PG&E Letter DCL-14-076

Docket No. 50-275, OL-DPR-80
Docket No. 50-323, OL-DPR-82
Diablo Canyon Units 1 and 2
Pacific Gas and Electric Company's Third Six-Month Status Report in Response to
March 12, 2012, Commission Order Modifying Licenses with Regard to
Requirements for Mitigation Strategies for Beyond-Design-Basis External Events
(Order Number EA-12-049)

**Pacific Gas and Electric Company's Third Six-Month Status Report for the
 Implementation of NRC Order EA-12-049**

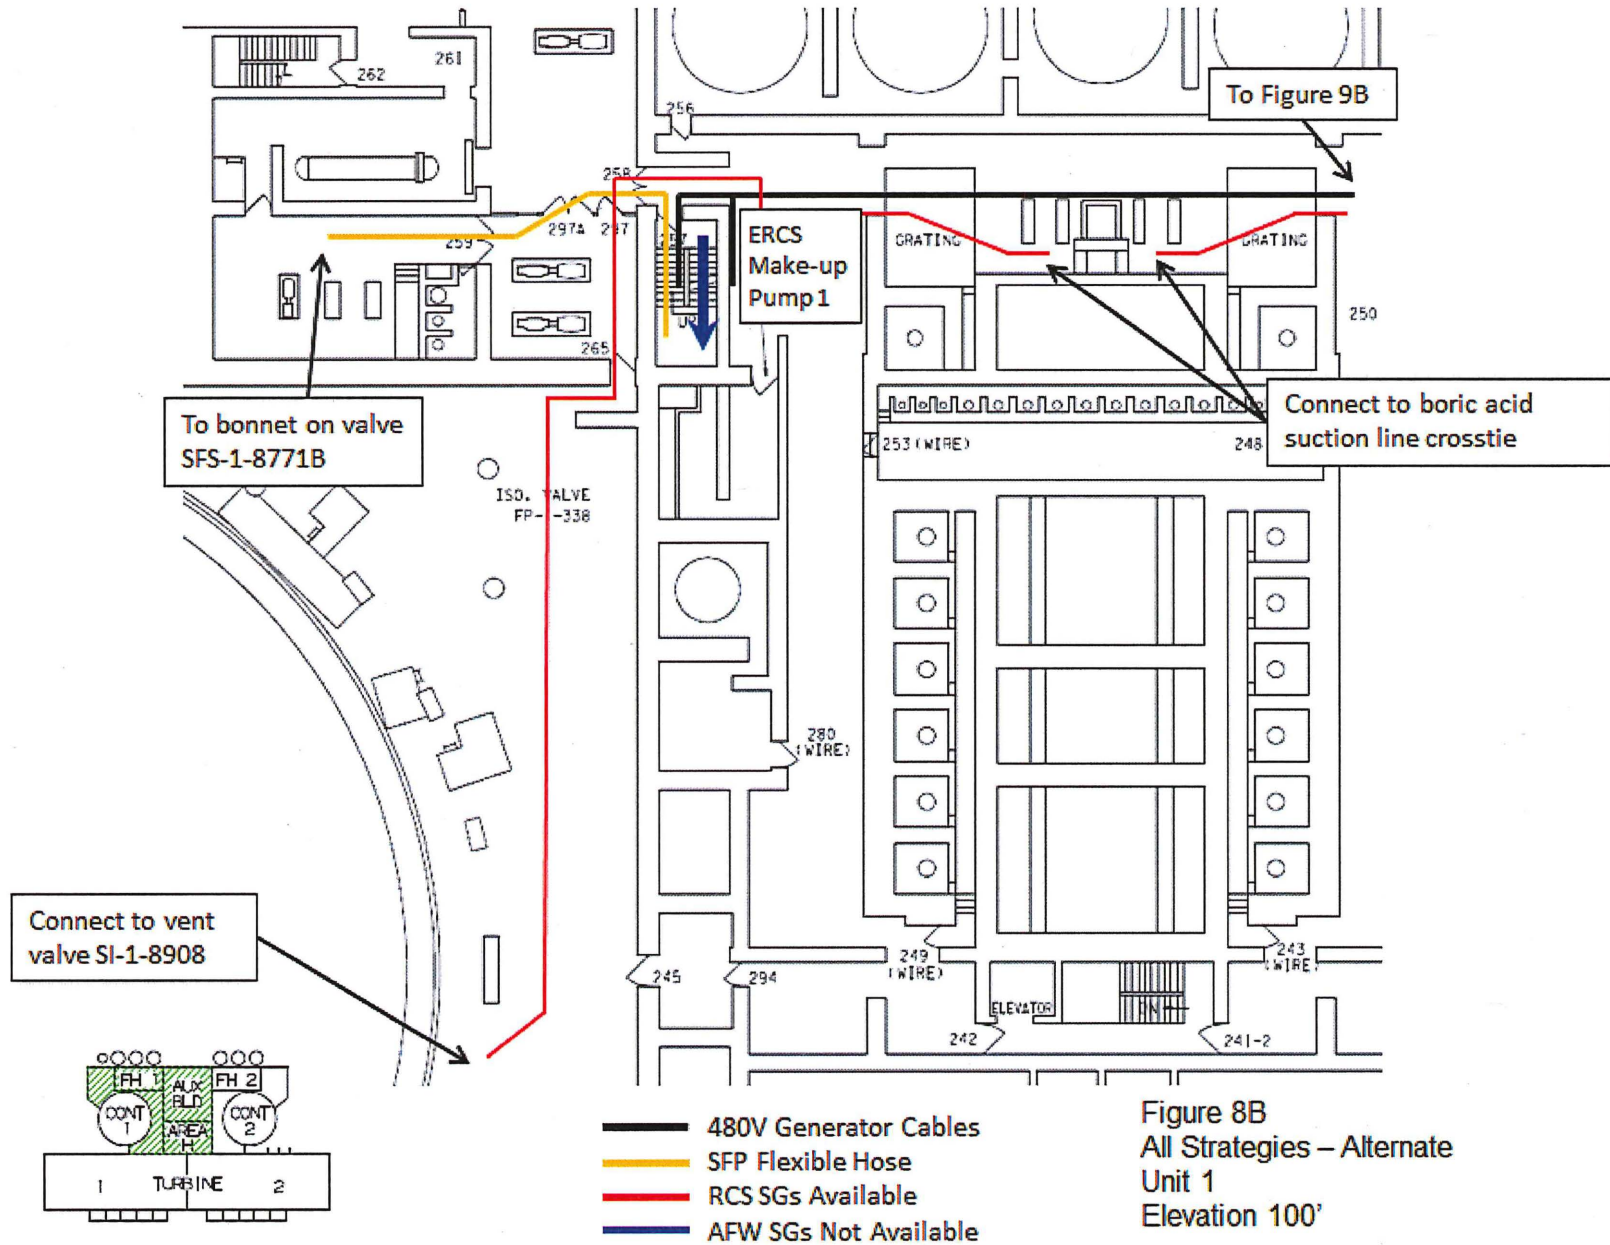
- (h) Clarified "To Unit 2" to "To Figure 9A."
- (6) Figure 8B Revisions:
- (a) Added staging location for the Unit 1 ERCS make-up pump.
 - (b) Added route for 480-V generator cables to the ERCS make-up pumps.

- (c) Updated the legend to include route for 480-V generator cables for powering the ERCS make-up pumps.
 - (d) Added note for SFP connection point to bonnet on valve SFS-1-8771B.

- (e) Clarified the legend to state "SFP Flexible Hose."
 - (f) Added note "To Figure 9B" for lines that connect to the Unit 2 ERCS make-up pump.
- (7) Figure 9A Revisions:

Figure 9A
 All Strategies – Alternate
 Unit 2
 Elevation 115'

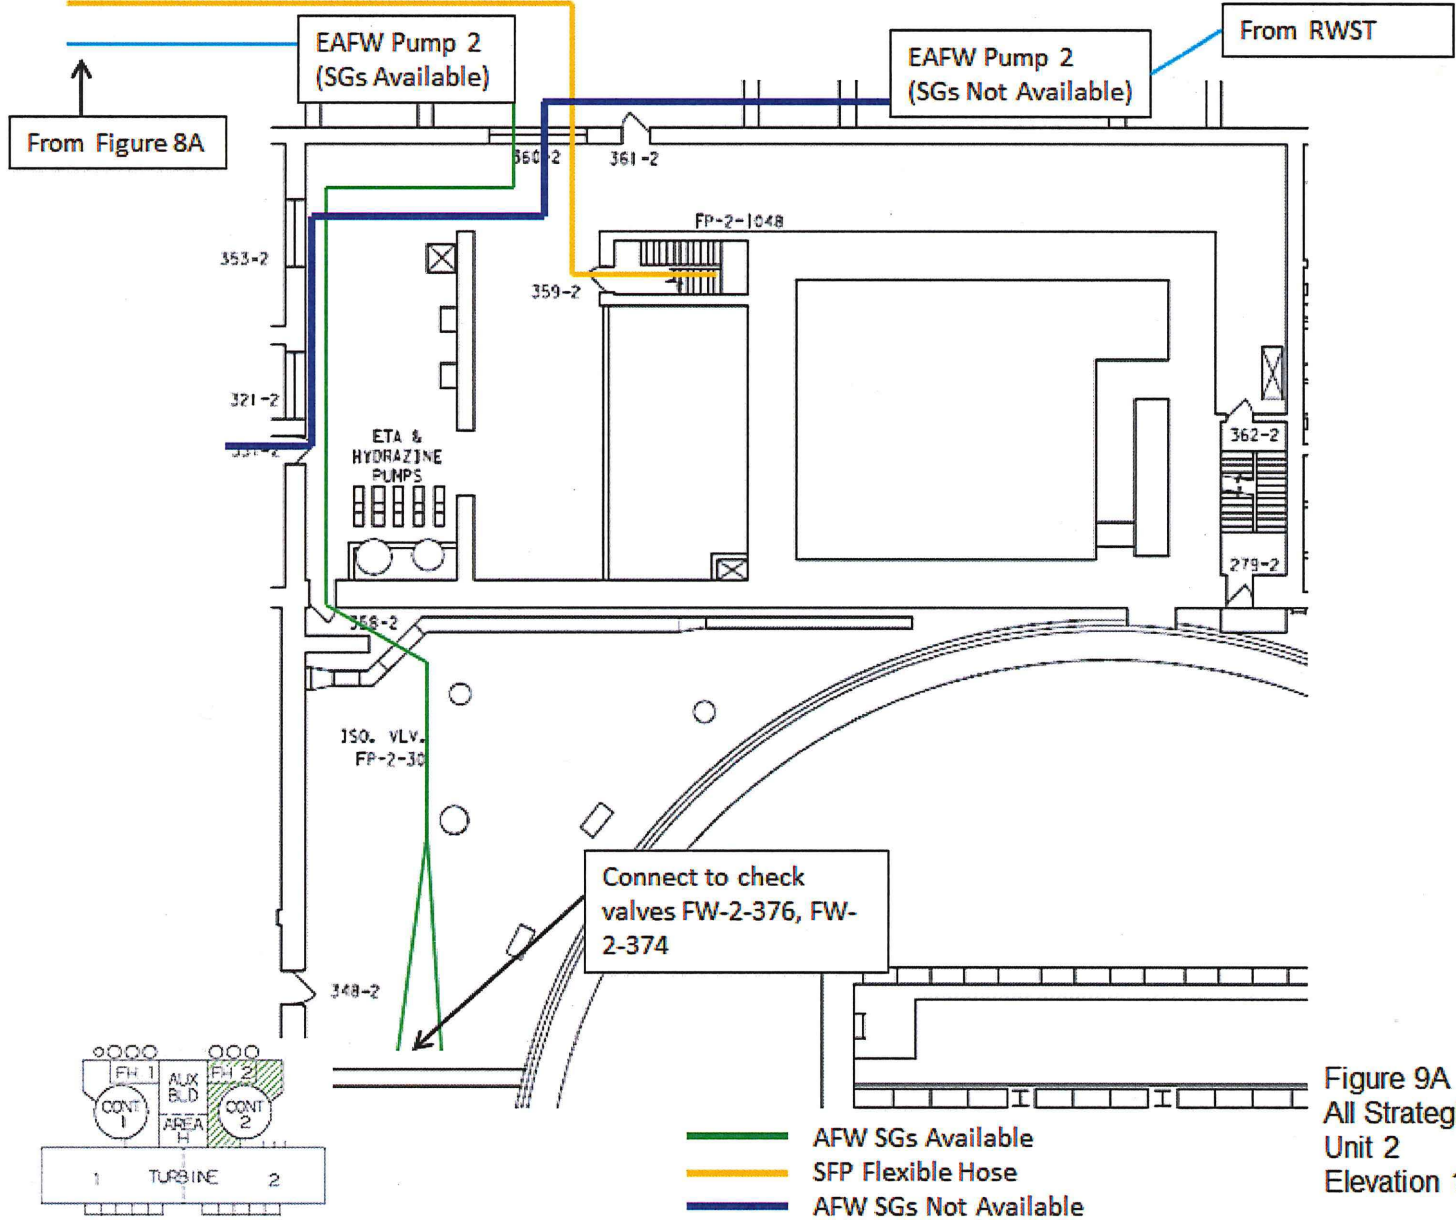
- (a) Removed the ESFP pump from the SFP hose line.
 - (b) Clarified the legend to state "SFP Flexible Hose."
 - (c) Clarified "From Unit 1" to "From Figure 8A."

Figure 9B
 All Strategies – Alternate
 Unit 2
 Elevation 100'

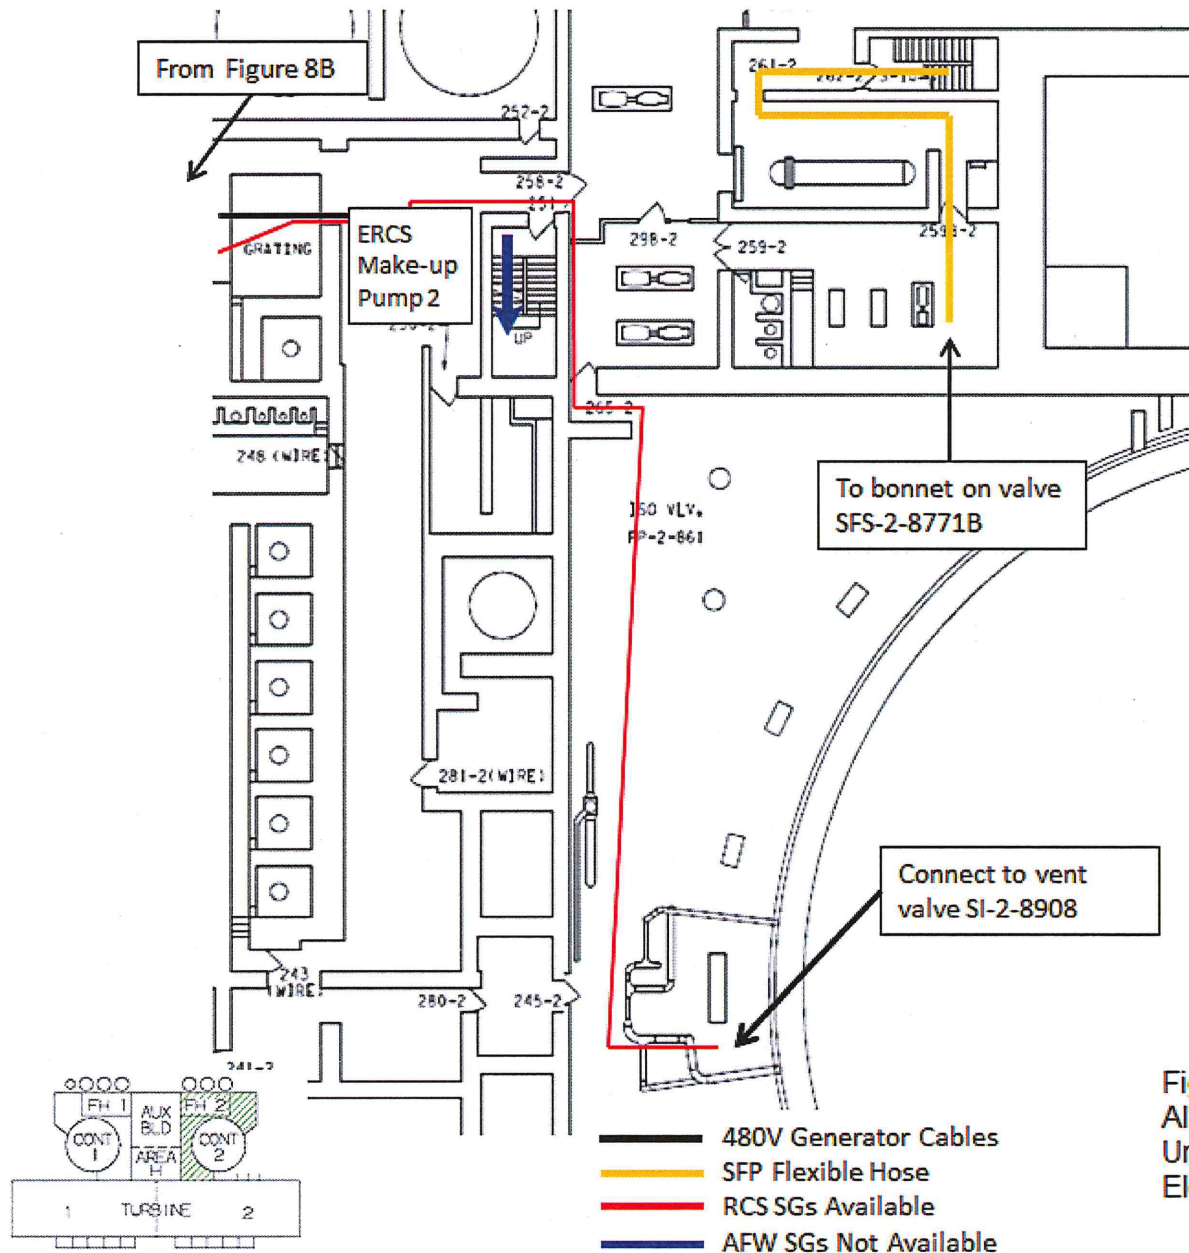
- (8) Figure 9B Revisions:
- (a) Added staging location for the Unit 2 ERCS make-up pump.
 - (b) Added route for 480-V generator cable to the ERCS make-up pump.

- (c) Updated the legend to include route for 480-V generator cables for powering the ERCS make-up pumps.
 - (d) Added note for SFP connection point to bonnet on valve SFS-2-8771B.
 - (e) Clarified the legend to state "SFP Flexible Hose."
 - (f) Added note "To Figure 8B" for lines that connect from the Unit 2 ERCS make-up pump.
- (9) Figure 16: Modified route for the SFP flexible hose to be routed up the stairs to the SFP.
- (10) Figure 17: Modified route for the SFP flexible hose to be routed up the stairs to the SFP.
- (11) Deleted Figure 18, which shows the SFP connection on the 100-foot elevation for Unit 1. This connection is already shown on Figure 8B.
- (12) Deleted Figure 19, which shows the SFP connection on the 100-foot elevation for Unit 2. This connection is already shown on Figure 9B.
